REGIONAL REVIEW NOTIFICATION

ARC REVIEW CODE: R2109131

Name of Proposal: Emory Graduate and Professional Housing #3378

EMORY GRADUATE AND PROFESSIONAL HOUSING DRI
City of Atlanta
Natural Resources Group Review Comments
September 8, 2021

DRI SITE PLAN

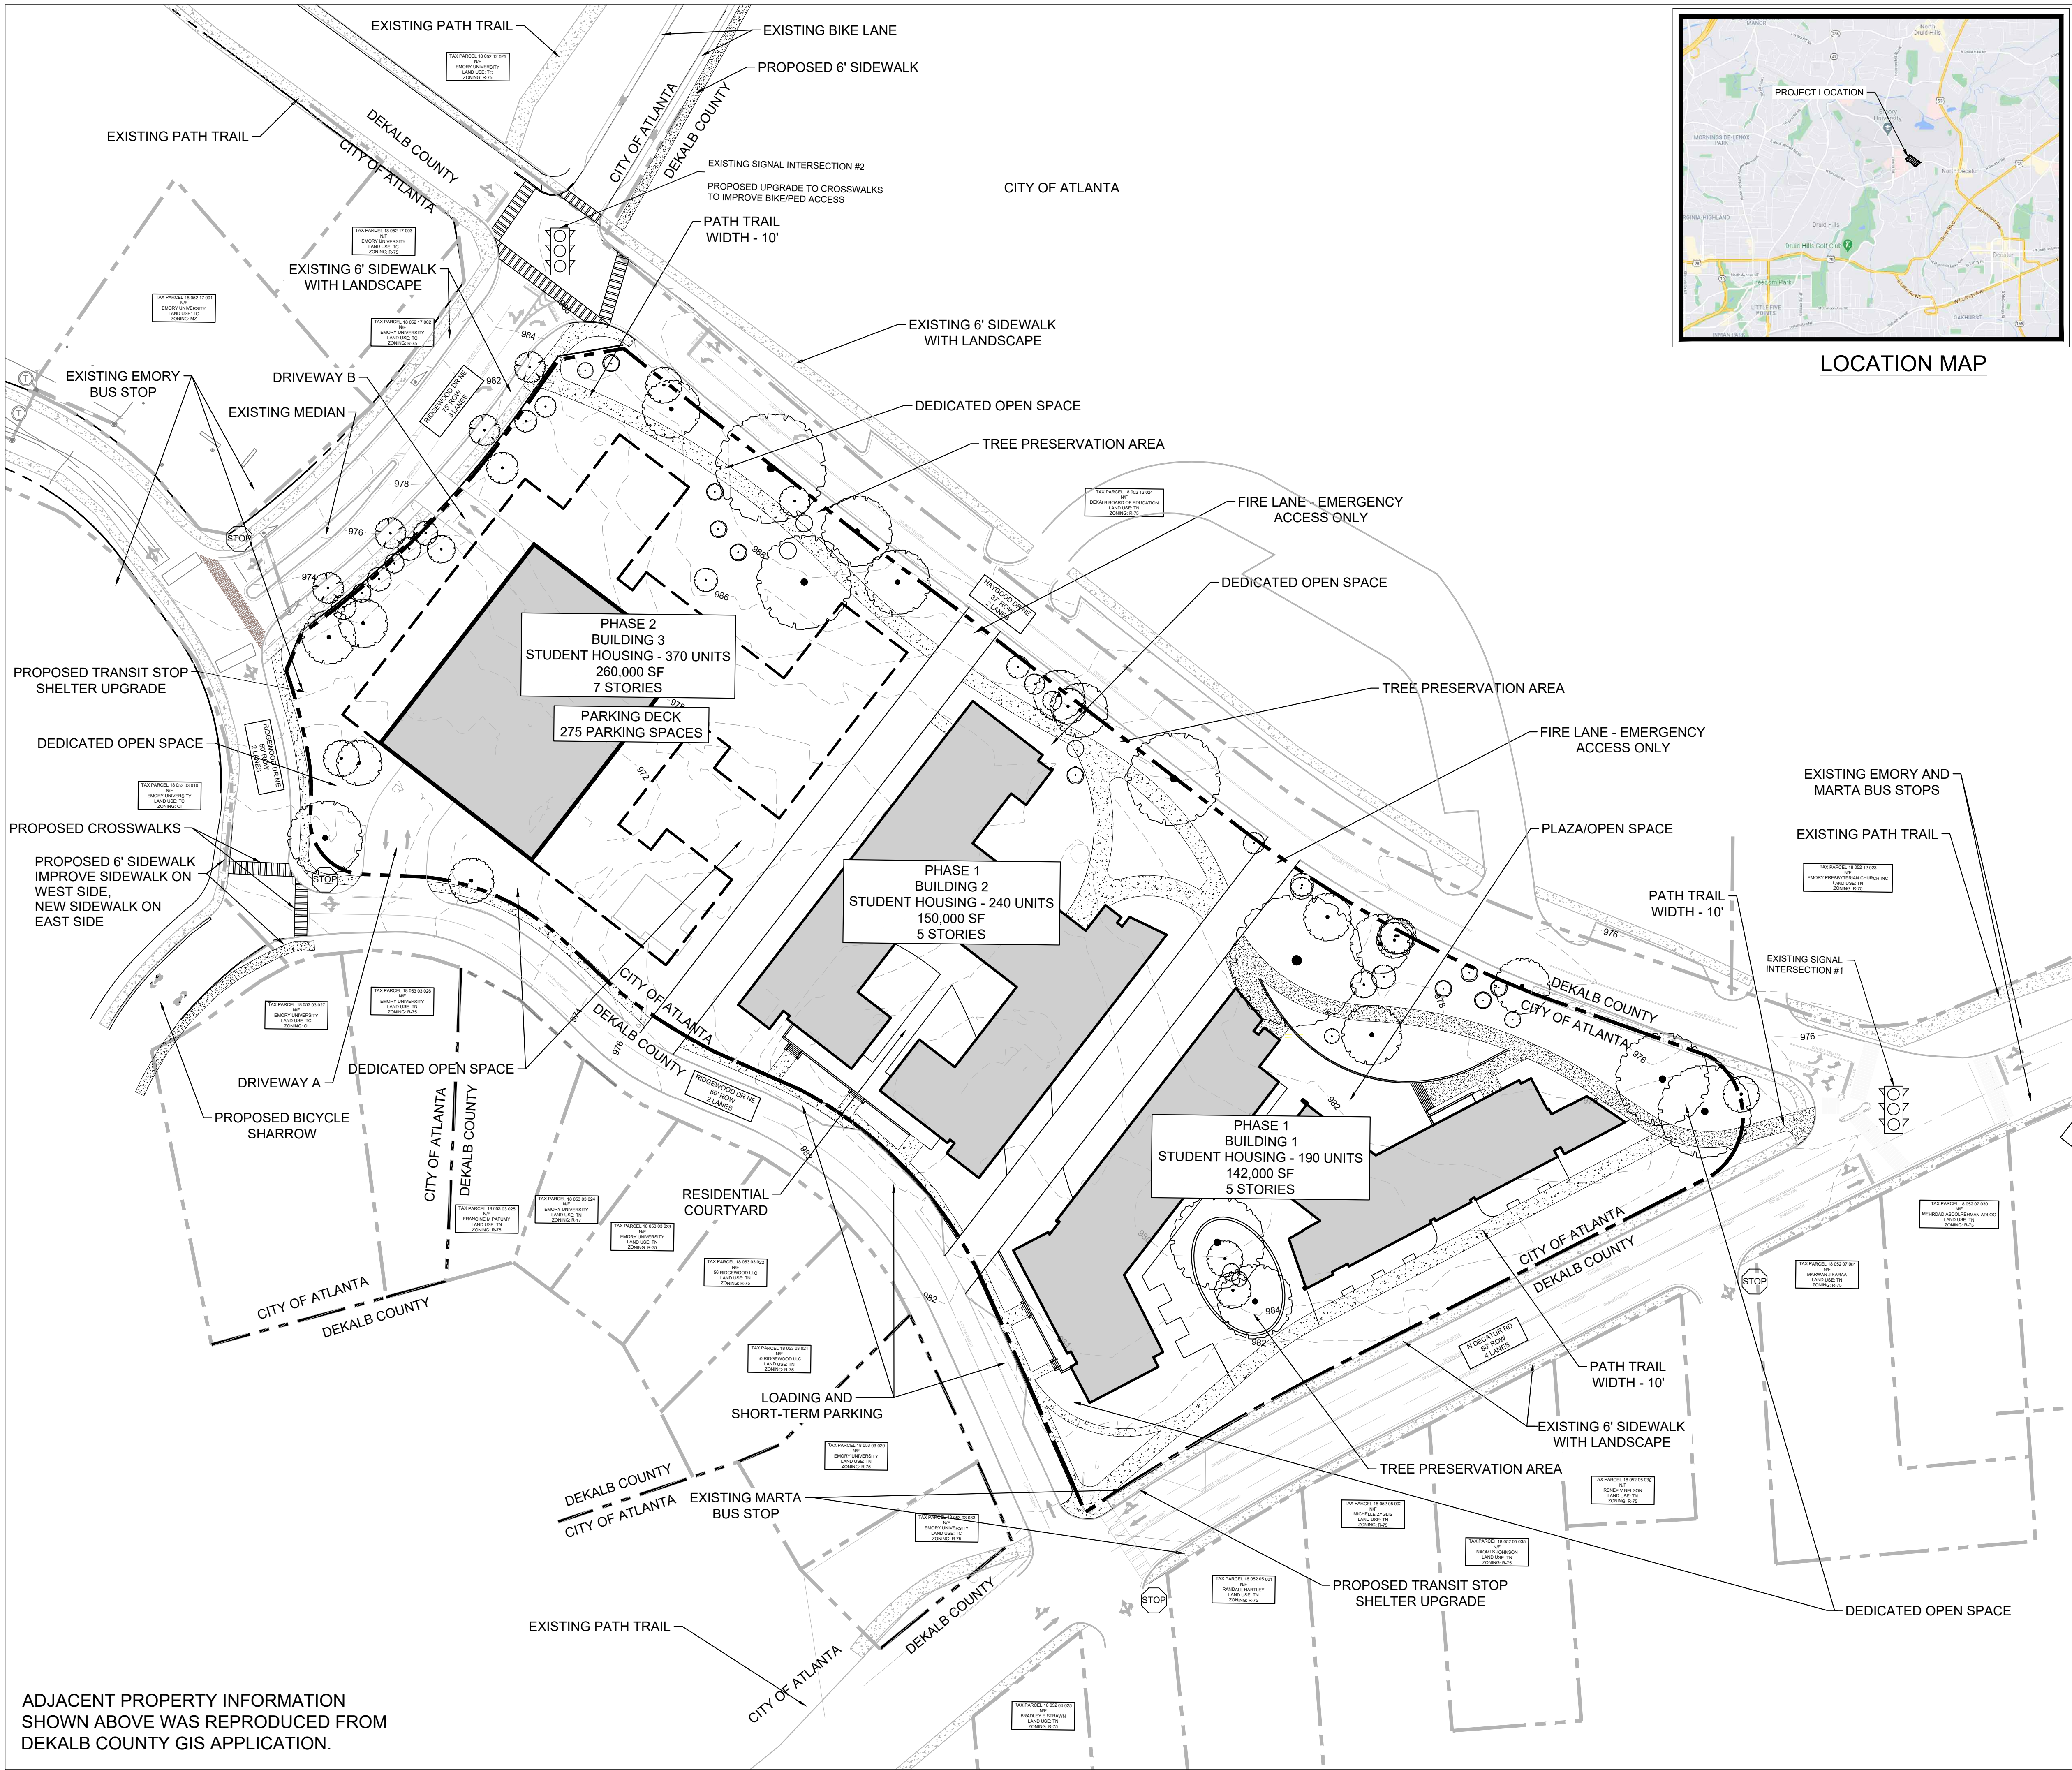
The project is subject to the Emory Campus Parking Overlay District, which has a maximum of 0.75 parking spaces per bed for residential uses. The DRI proposes providing substantially fewer parking spaces than the maximum. Parking is also planned to be unbundled from residential leases. Additionally, Emory restricts parking passes to a single parking facility, such that a resident who purchases a parking pass on-site at this project will not have access to another parking facility on campus. Per City of Atlanta standards, bicycle parking is required at 1 space per 10 residential units with a maximum of 50 bicycle parking spaces required in fixed bicycle parking racks and enclosed bicycle parking spaces. The project intends to include enclosed bicycle parking spaces in the parking deck and fixed racks adjacent to each of the residential buildings.

To capitalize on the DRI's potential, care should be taken to ensure that the development, as constructed, promotes an interconnected, functional, clearly marked and comfortable pedestrian experience on all streets, paths, entrances, and parking areas. The development team is also encouraged to ensure that the provided bicycle racks or storage facilities meet or exceed the above-mentioned City standard in terms of design, security and convenience. To the maximum extent possible, new driveways and intersection corners where pedestrians will cross should be constructed with minimal curb radii to reduce speeds of turning vehicles and decrease crossing distances for pedestrians.

The project can further support The Atlanta Region's Plan in general by incorporating other aspects of regional policy, including green infrastructure and/or low-impact design, e.g., pervious pavers, rain gardens, vegetated swales, etc., throughout the site in general – especially in parking areas, on site driveways, and as part of any improvements to site frontages. Additional comments on water resources from ARC's Natural Resources Group are attached. The DRI site plan does show significant tree preservation

and open space planned for the site, which is a positive step to maintain the residential character of the existing area at the edge of Emory's campus.

09. Does the site plan provide for the construction of publicly accessible local road or drive aisle connections with adjacent parcels?

- ☐ YES (*connections to adjacent parcels are planned as part of the development*)
- ☐ YES (*stub outs will make future connections possible when adjacent parcels redevelop*)
- ☒ NO (*the site plan precludes future connections with adjacent parcels when they redevelop*)
- ☐ OTHER (*Please explain*)

10. Does the site plan enable pedestrians and bicyclists to move between destinations within the development site safely and conveniently?

- ☒ YES (*sidewalks provided on all key walking routes and both sides of roads whenever practical and bicyclists should have no major issues navigating the street network*)
- ☐ PARTIAL (*some walking and bicycling facilities are provided, but connections are not comprehensive and/or direct*)
- ☐ NO (*walking and bicycling facilities within the site are limited or nonexistent*)
- ☐ NOT APPLICABLE (*the nature of the development does not lend itself to internal walking and bicycling trips*)

11. Does the site plan provide the ability to construct publicly accessible bicycling and walking connections with adjacent parcels which may be redeveloped in the future?

- ☒ YES (connections to adjacent parcels are planned as part of the development)
- ☐ YES (stub outs will make future connections possible when adjacent parcels redevelop)
- ☐ NO (the development site plan does not enable walking or bicycling to/from adjacent parcels)
- ☐ NO (the site plan precludes future connections with adjacent parcels when they redevelop)
- ☐ NOT APPLICABLE (adjacent parcels are not likely to develop or redevelop in the near future)
- ☐ NOT APPLICABLE (the nature of the development or adjacent parcels does not lend itself to interparcel walking and bicycling trips)
